PLANNING COMMISSION MEETING AGENDA REGULAR MEETING

5. PLANNED UNIT DEVELOPMENT (File Number PUD 020 JPLN2023-0021) – CONCEPT DEVELOPMENT PLAN (CDP) AND PRELIMINARY DEVELOPMENT PLAN (PD) APPROVAL – The Village of Hastings PUD, East side of Livernois, north of Square Lake, PIN 88-20-03-301-088, -023, -024, -025 and 88-20-03-351-004, Section 3, Presently zoned NN (Neighborhood Node “Q”) and R-1B (One Family Residential) Zoning Districts.

PUD and Preliminary Development Plan Approval Review For City of Troy, Michigan

Action Requested: PUD and Preliminary Development Plan Approval Review

ENLARGED EVA PLAN
SCALE: 1"=20'

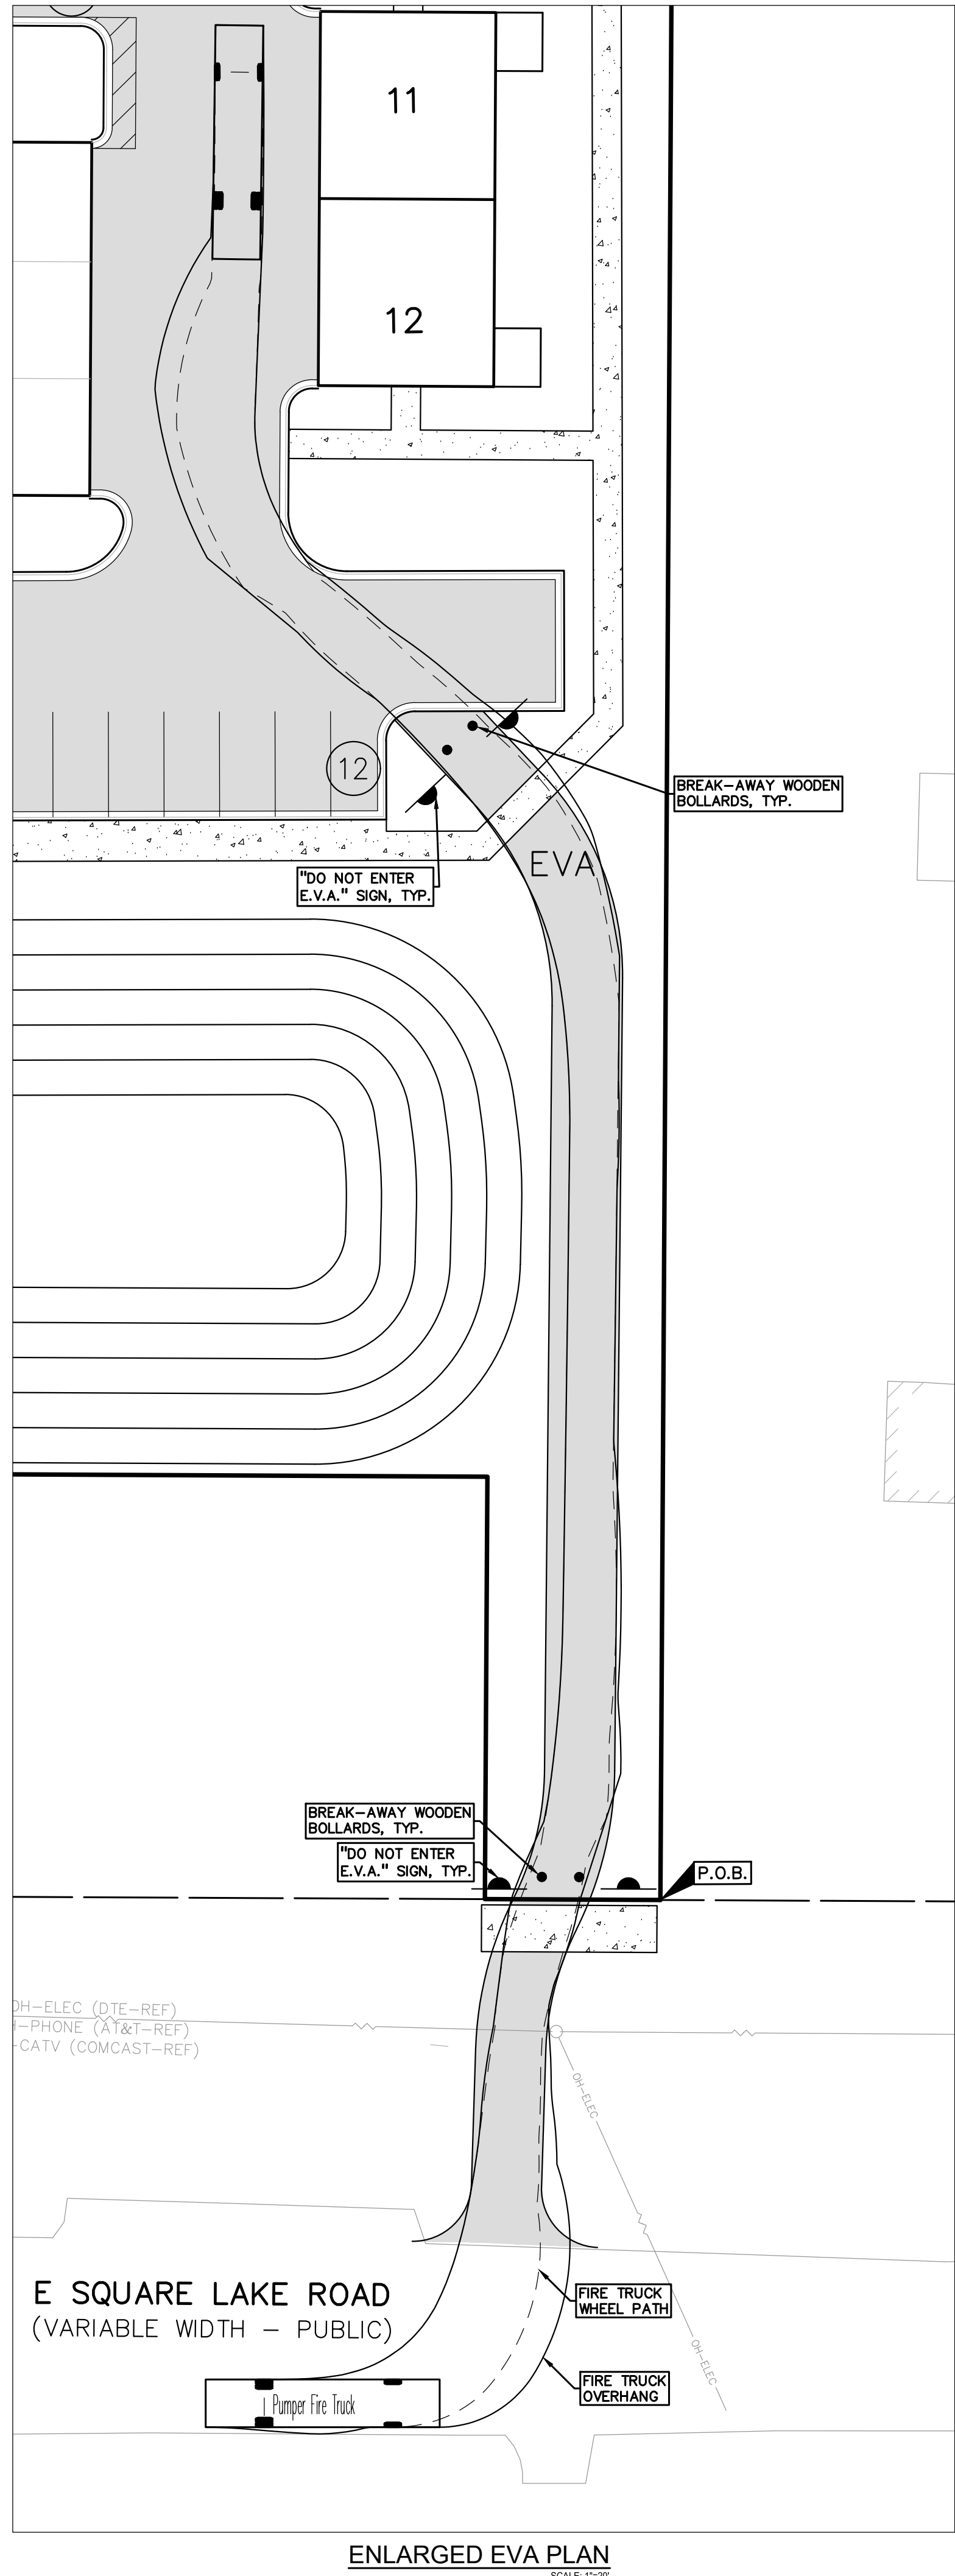
The site will be accessed from Livernois Road via a two-lane entry. There is a one-lane Emergency Vehicular Access (EVA) proposed from Square Lake Road into the southeastern portion of the development. Based on Planning Commission comments on April 9, 2024, the applicant has provided signage around the EVA to inform that this lane is meant for emergency vehicles only.

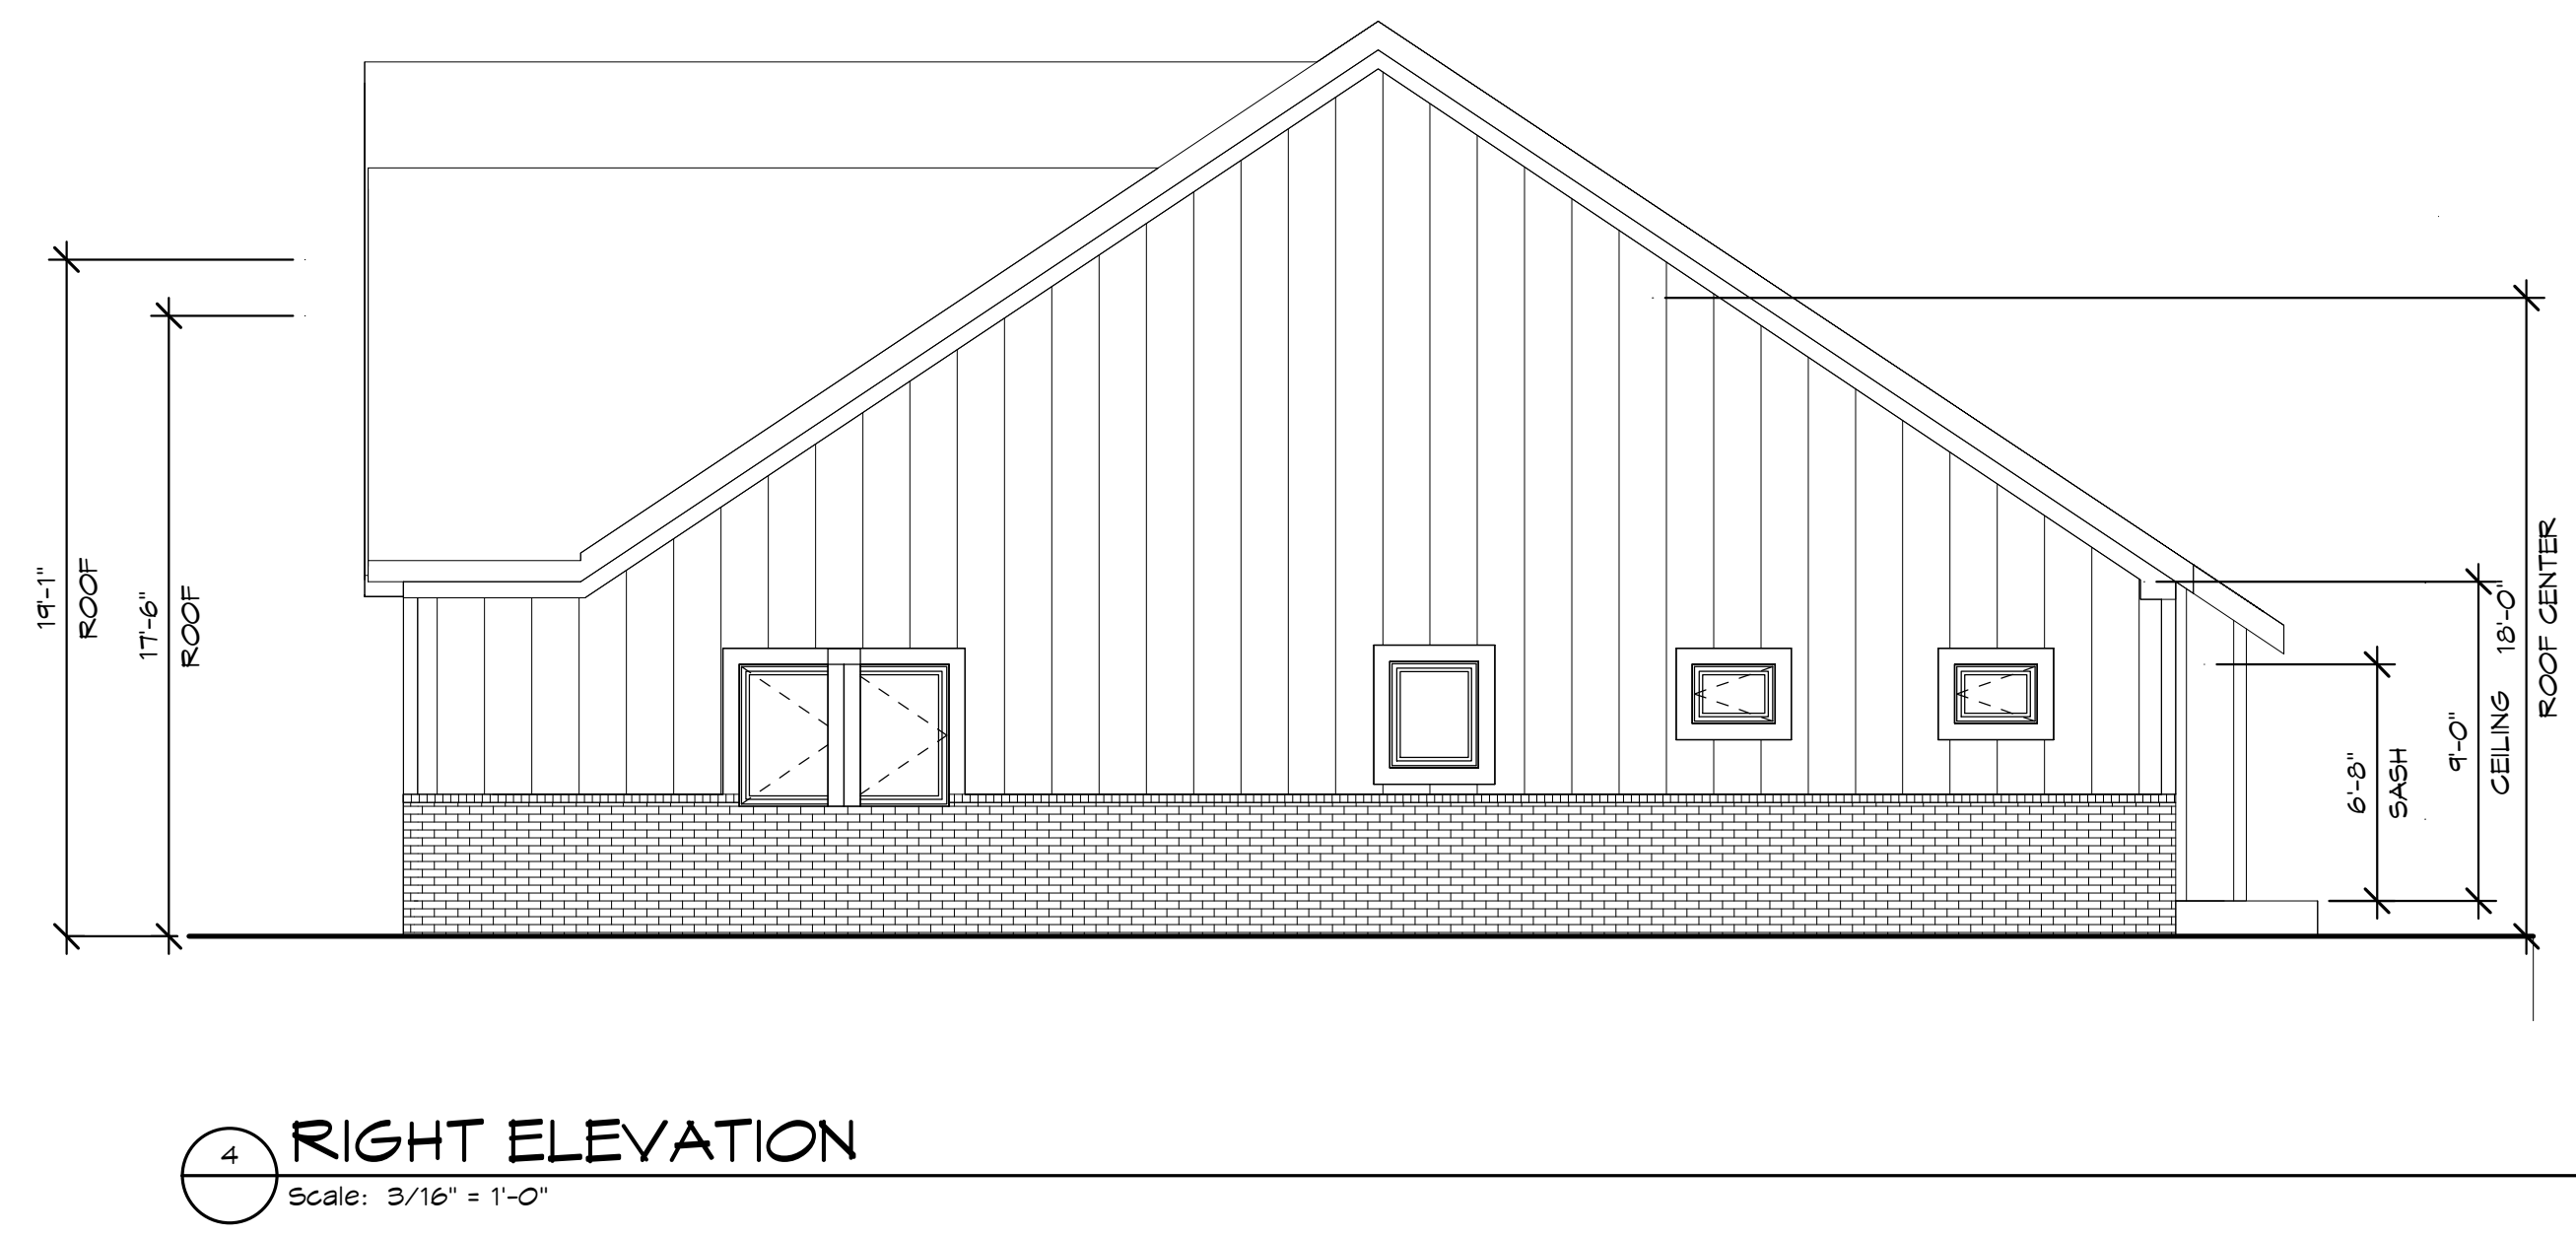
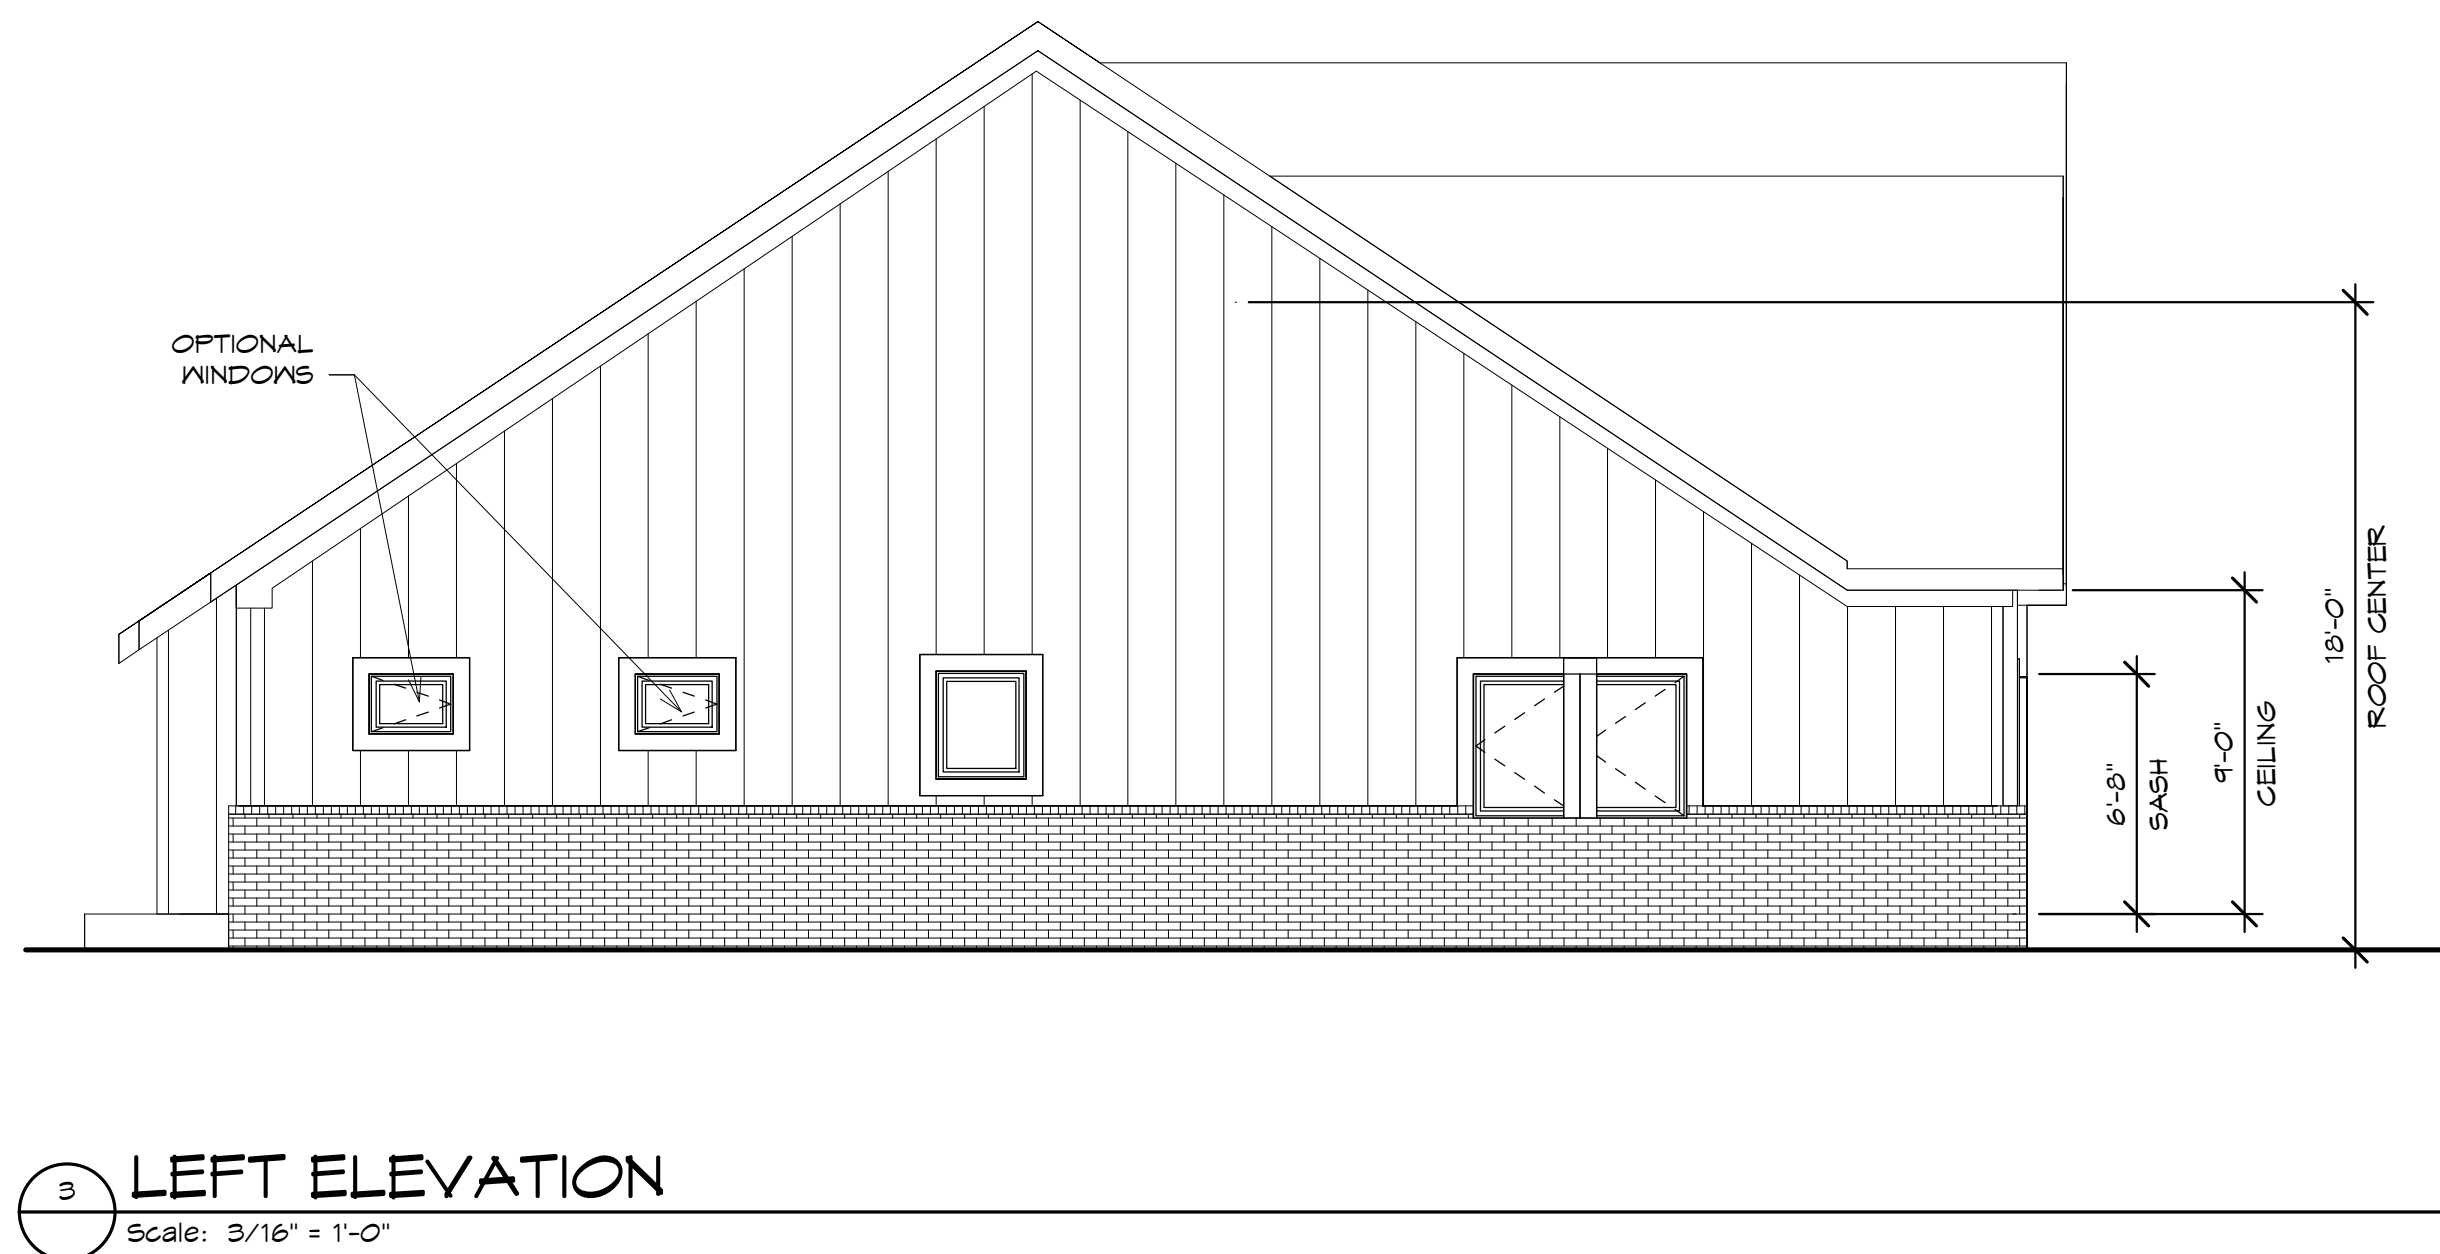
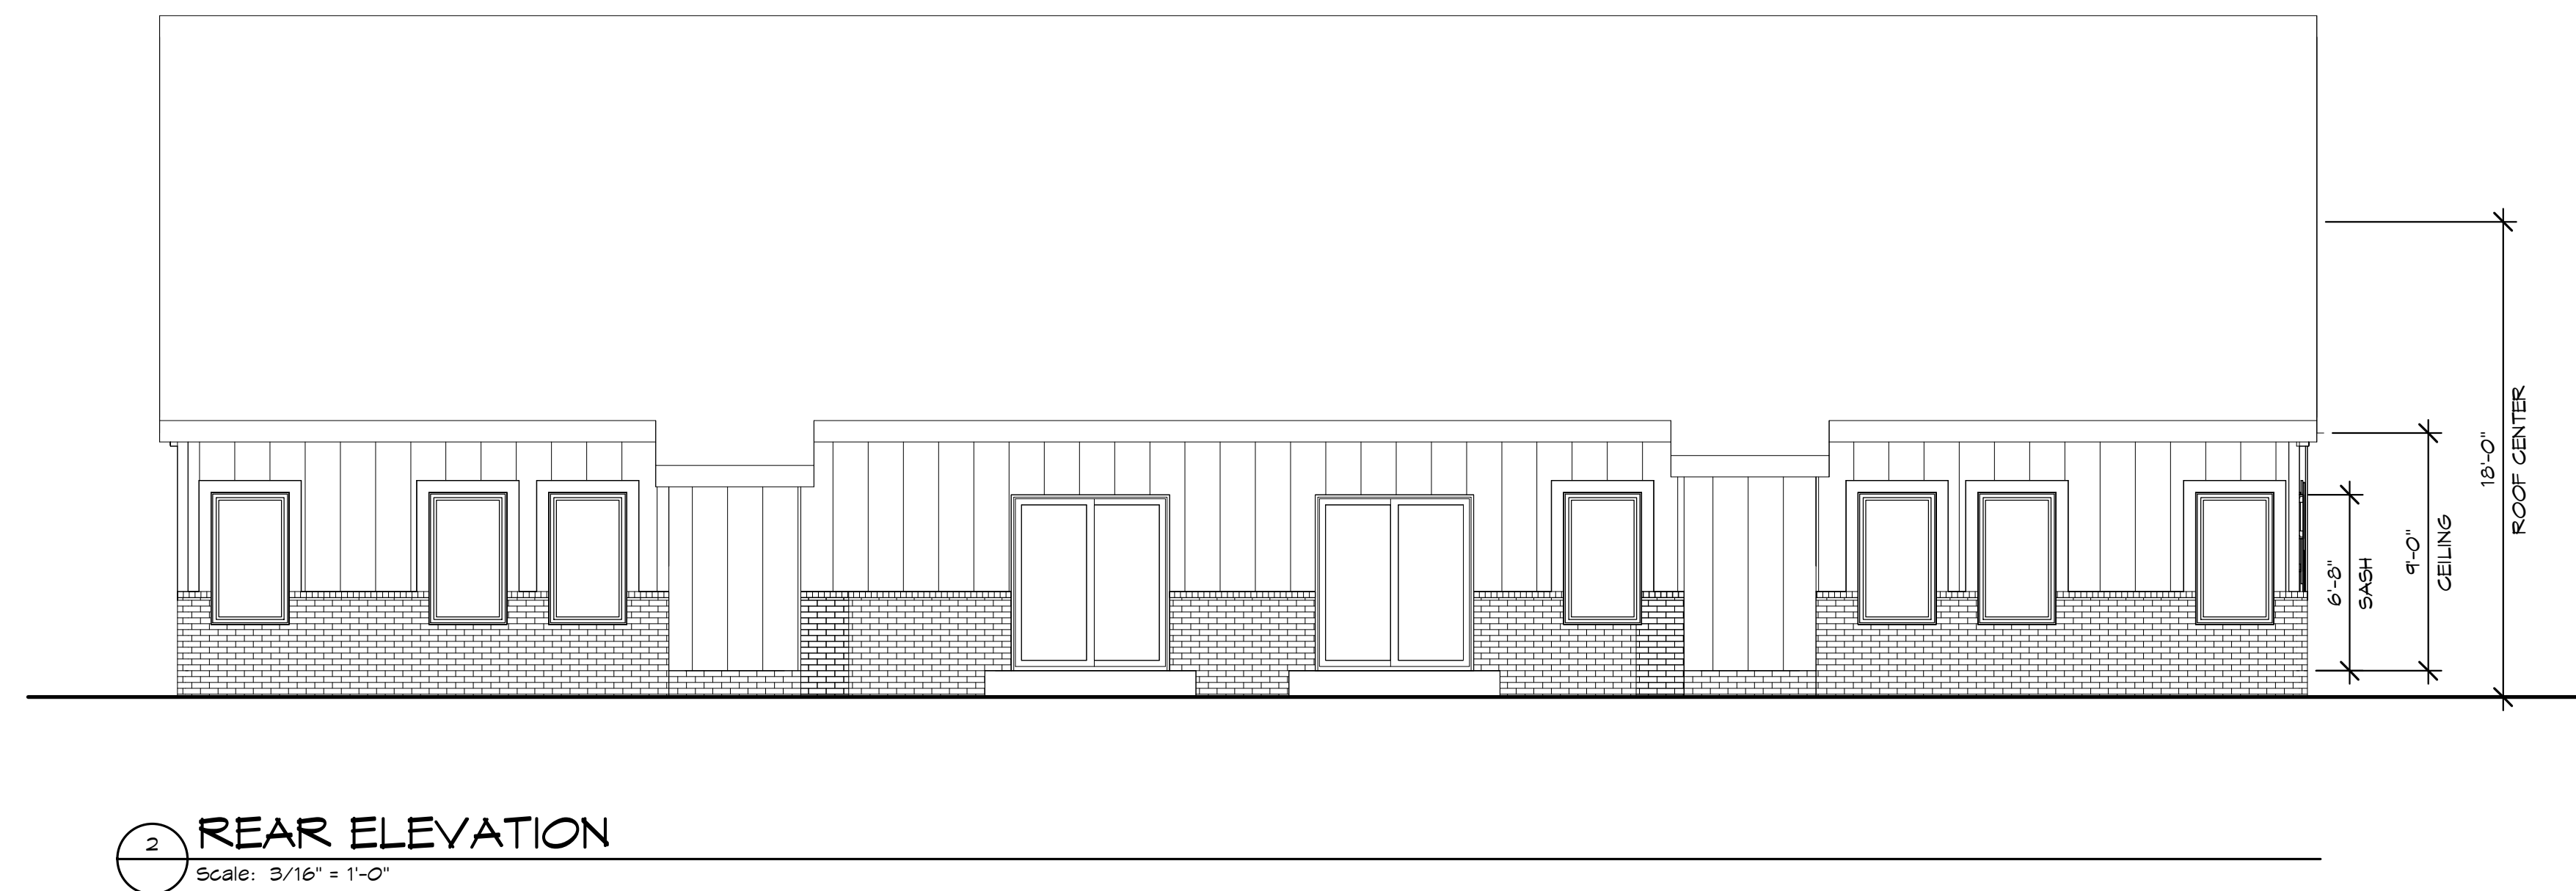
We note that since the April 9th Planning Commission meeting, the applicant has revised aspects of the building design to address architectural concerns. The “snout nose” appearance of the ranch units has been reduced, and more windows and architectural details have been incorporated to enhance natural light and building appearance. See the latest colored renderings below.

Items to be Addressed: *Planning Commission to evaluate proposed architecture in accordance with Site Plan Review Design Standards of Section 8.06.*
